### CONSTRUCTION REPORT

Project: River Center Branch Library

Report No.: 028

Site Visit Date/Time: 01-25-2018

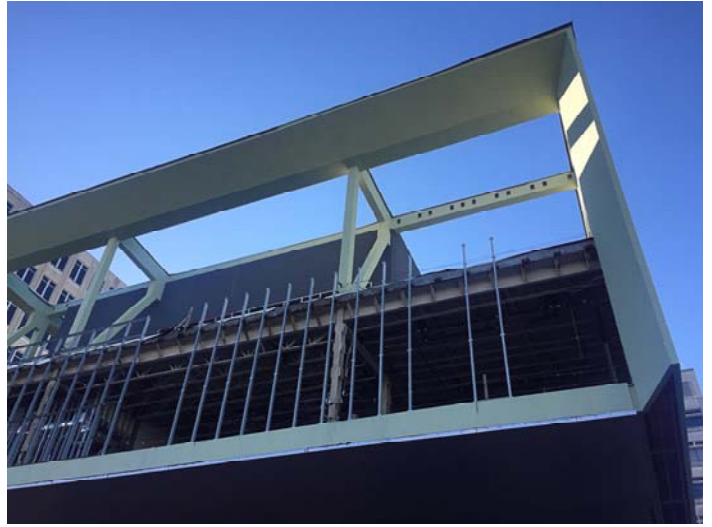
- We need to ensure that the TPO roofing is properly terminated at the up turned wall. Having the proper flexible flashing and overlap with the liquid applied VP material is key and required according to the bid documents. There are areas on the 4th floor roof that have not yet been completed, but have TPO roofing with a metal flashing piece installed yet no Liquid Applied VP overlap.
